Botley West Solar Farm

Change Request 2: Change Report

September 2025

PINS Ref: EN010147

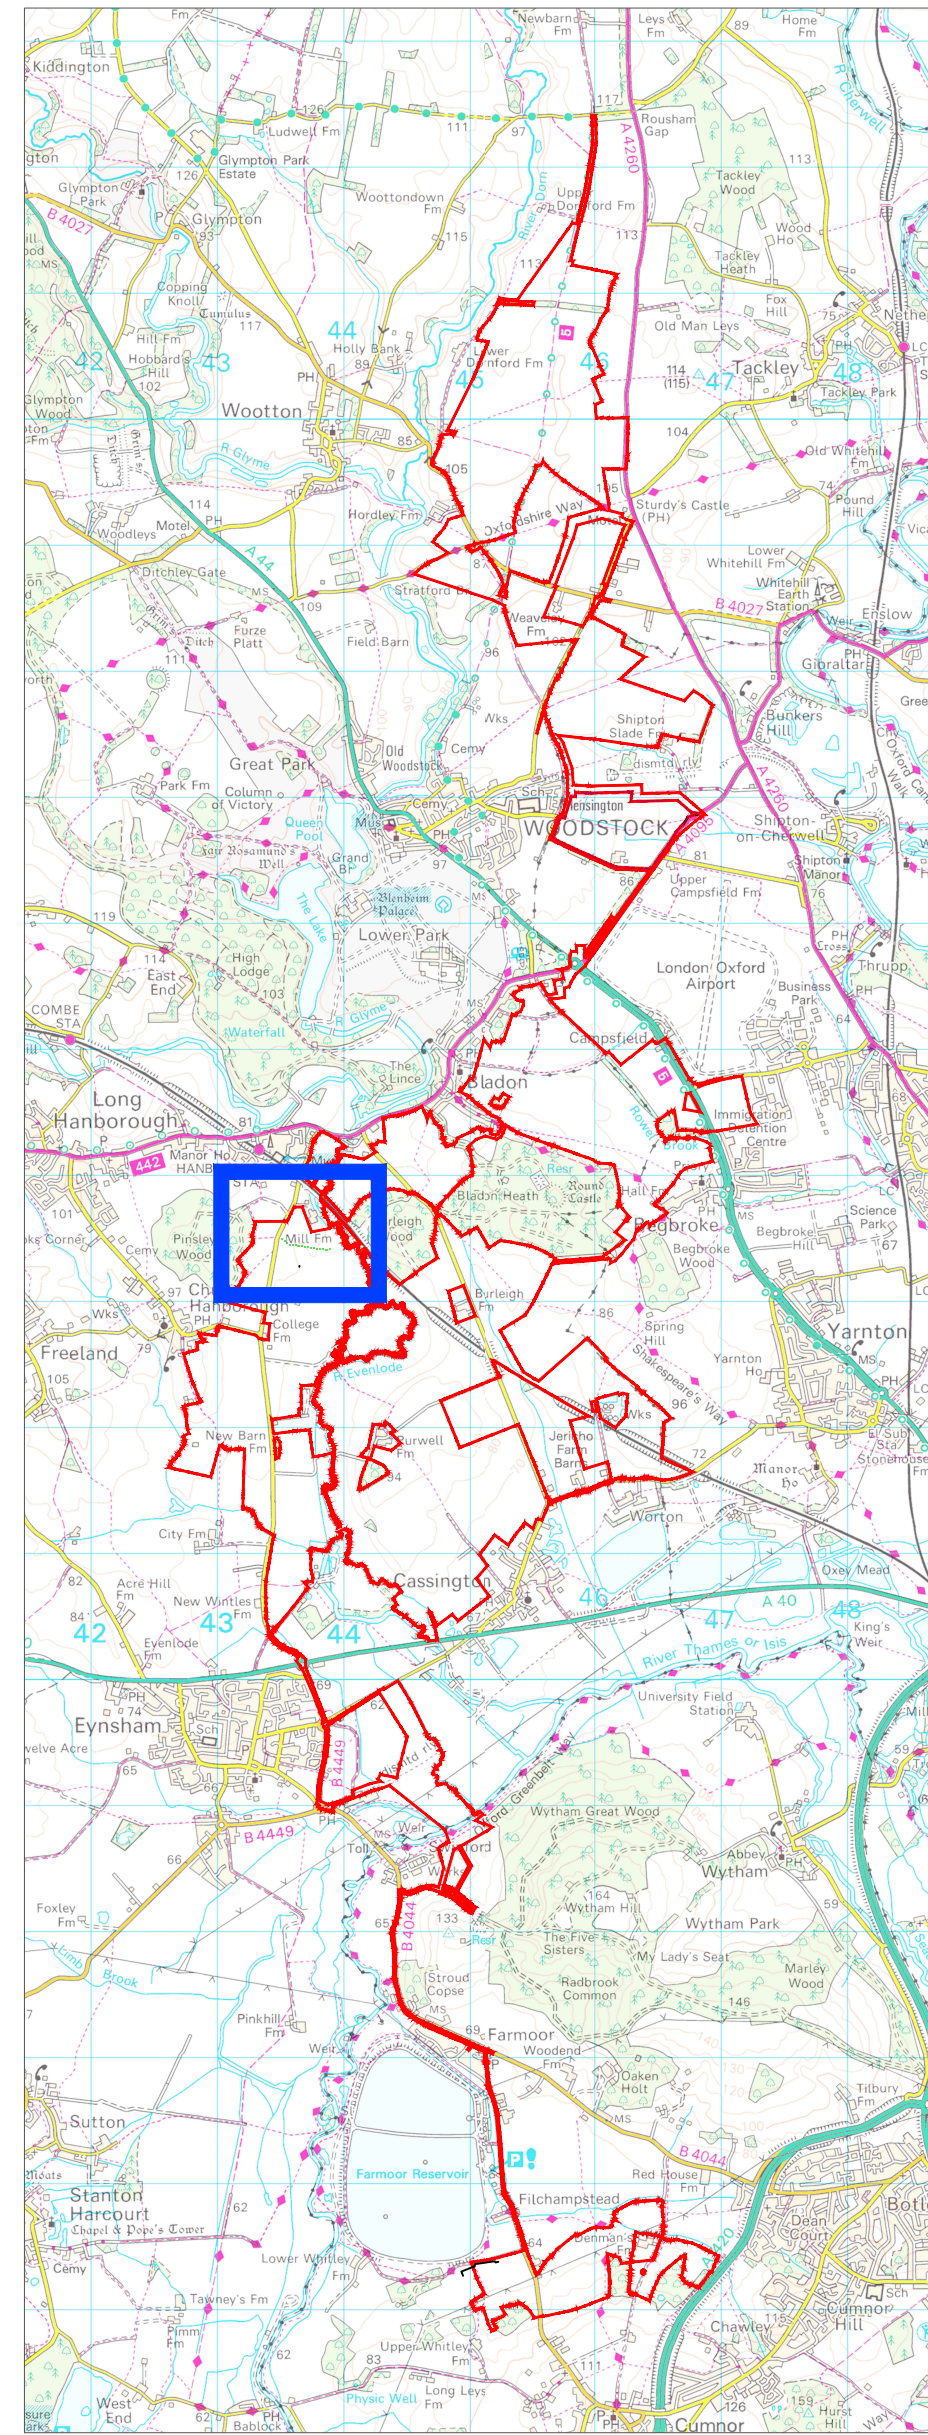
(1) Remove solar installation area, fence, maintenance roads and gates (6.26ha)

Change Request 2 - Change 4

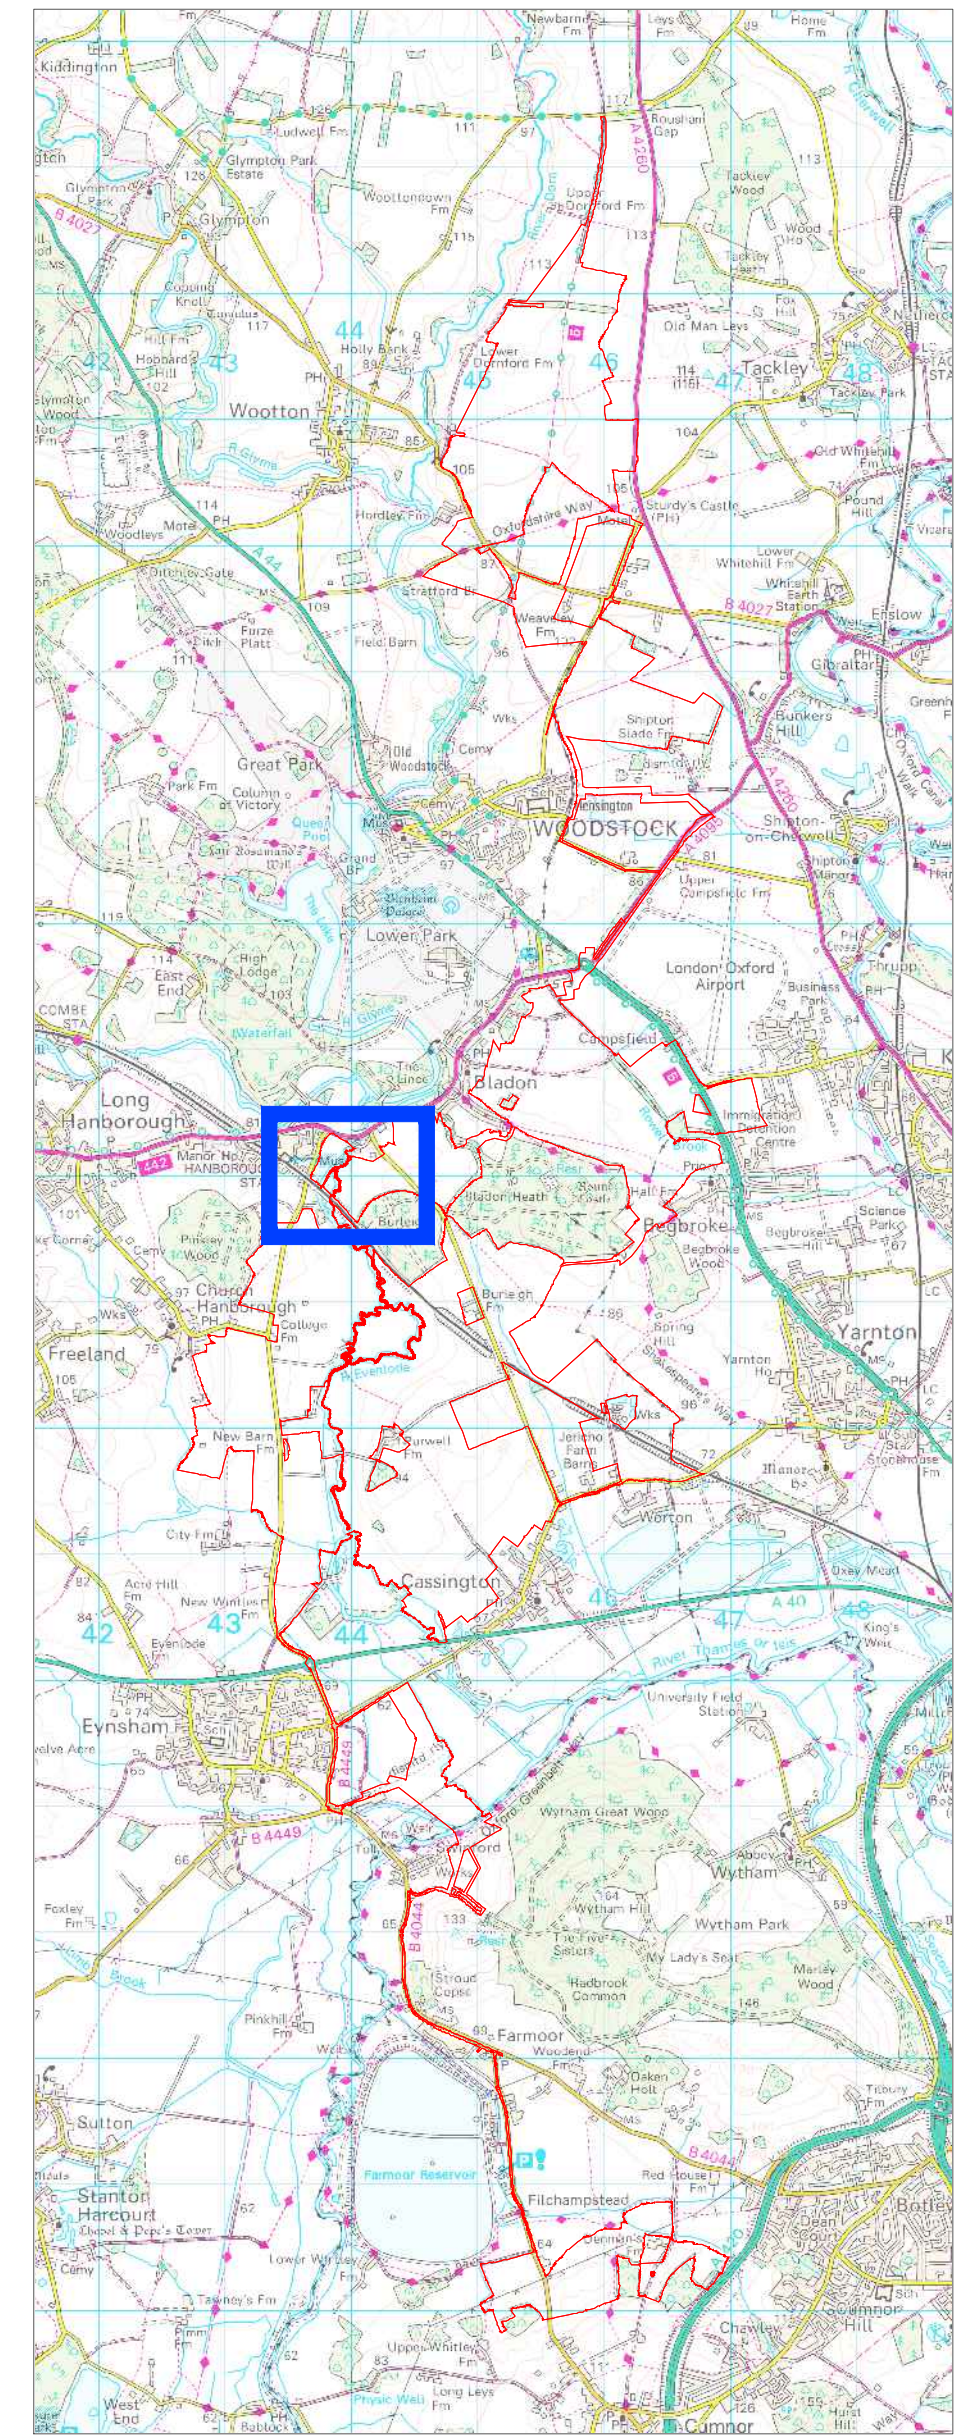
- 2.7.1 The Applicant is aware of a restrictive covenant which prevents the construction of 'buildings' over Plots 6-18, 6-19, 8-06, 8-07, 8-13, 8-14, 8-15, 8-16, on which the Applicant proposed solar arrays and related infrastructure. Notwithstanding, the Applicant has continued to engage with the affected landowner to try and find a reasonable alternative proposal. To date, the IP has maintained his position that he does not want solar installation over the relevant land parcel. The Applicant is therefore proposing to reduce the Order Limits and remove its powers of solar installation over all of the affected land. This will result in a loss of approximately 6.26ha of installation area and the re-routing of part of the 33kV cable. The freed-up land would be removed from the Order Limits and remain in agricultural use. This change will result in alterations to the Order Limits in the form of a reduction of approximately 11.78 ha.

Change Request 2 - Change 5

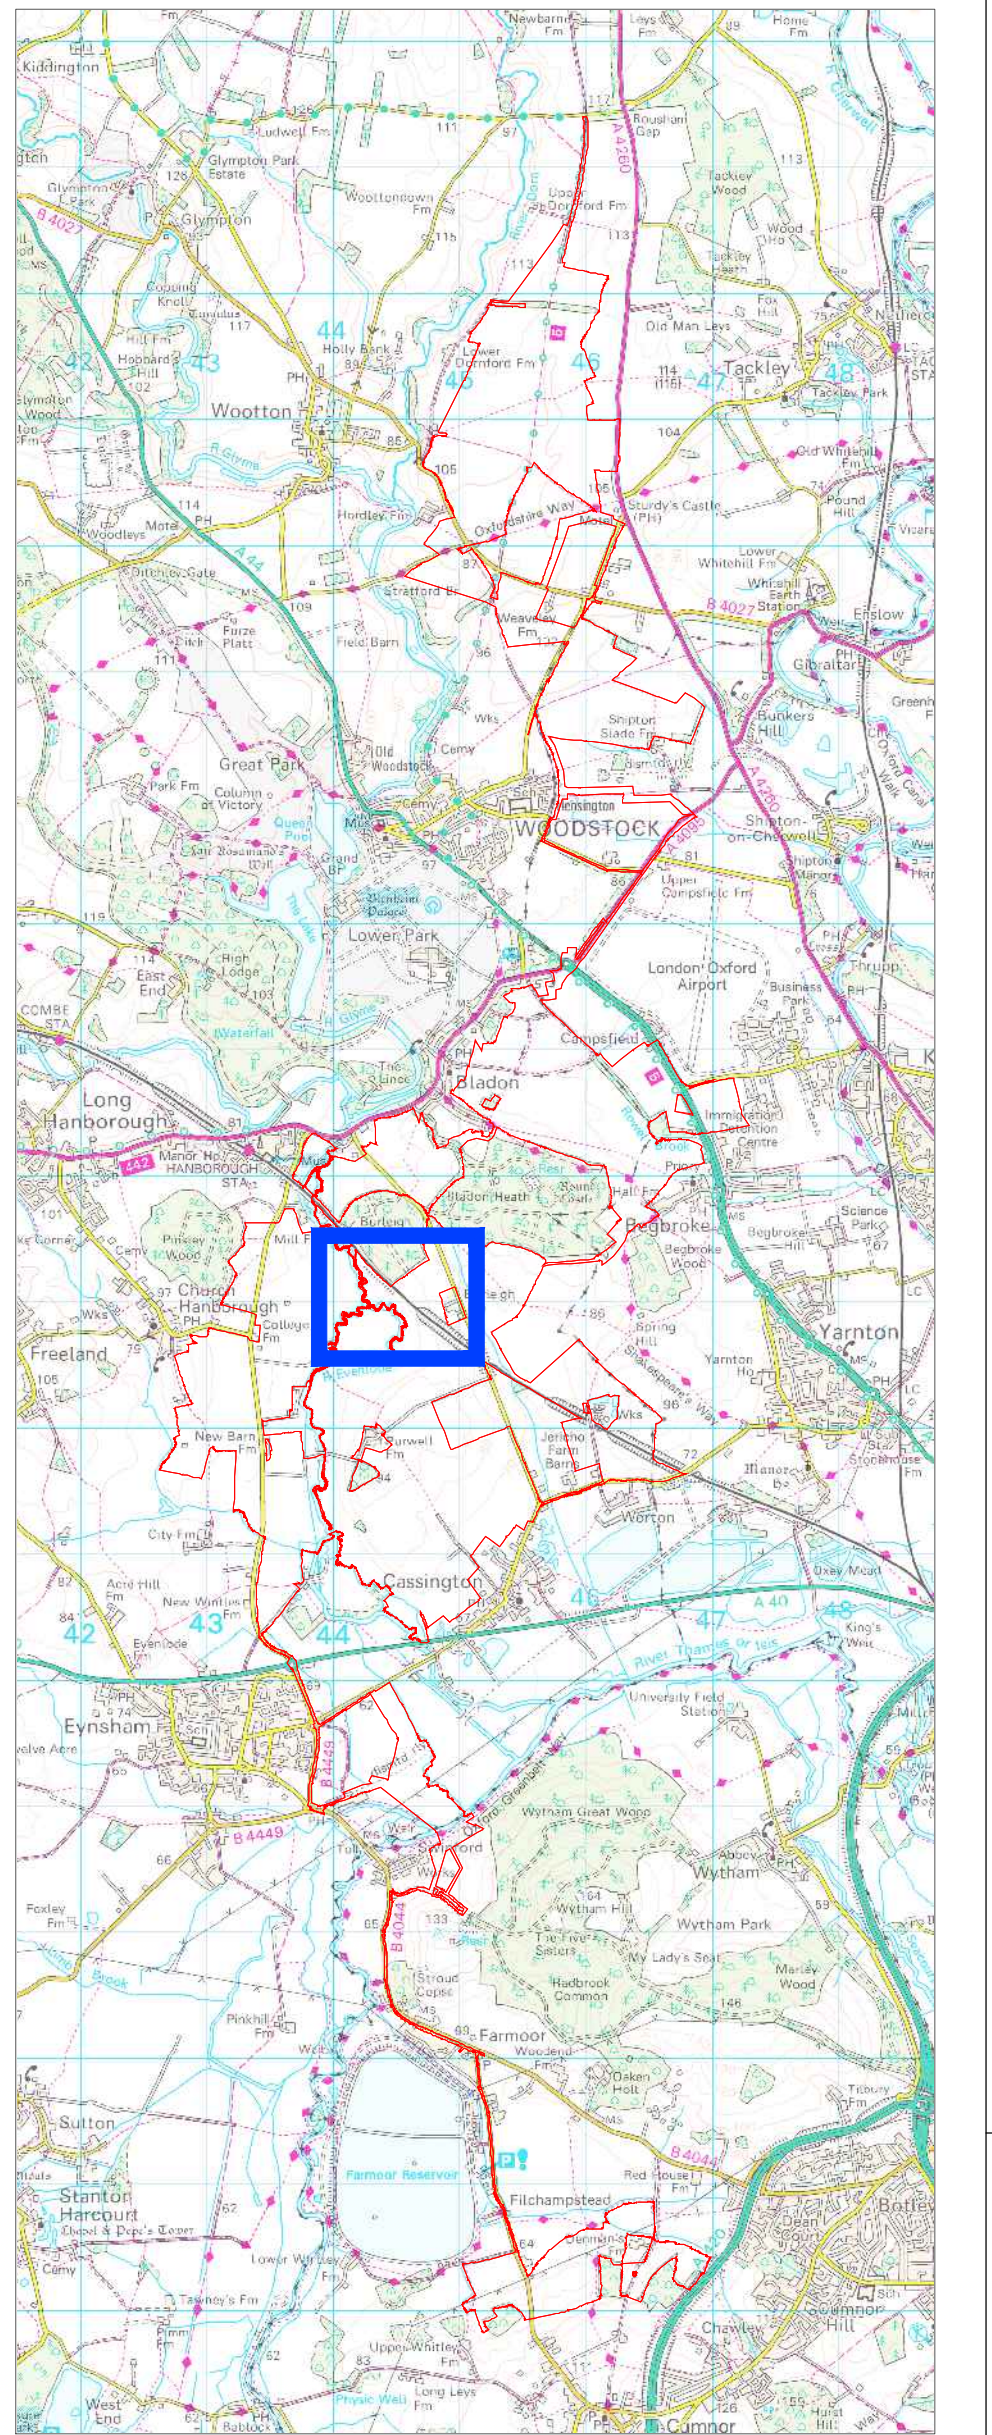
- 2.8.1 As a result of a base mapping error, the Applicant has identified minor anomalies where the solar installation slightly overlaps with Flood Zone 2 or 3 throughout the Project site. The Applicant is committed to not develop within Flood Zone 2 or 3 and so is proposing to correct this mapping anomaly. This has resulted in a small loss of installation area in several locations amounting to approximately 0.72 ha.
- 2.8.2 No new land interests would be engaged as a result of this change. No additional land outside the current Order Limits is required. Given the

(5) Remove solar installation area for Flood Zone protection and management (0.0048ha)
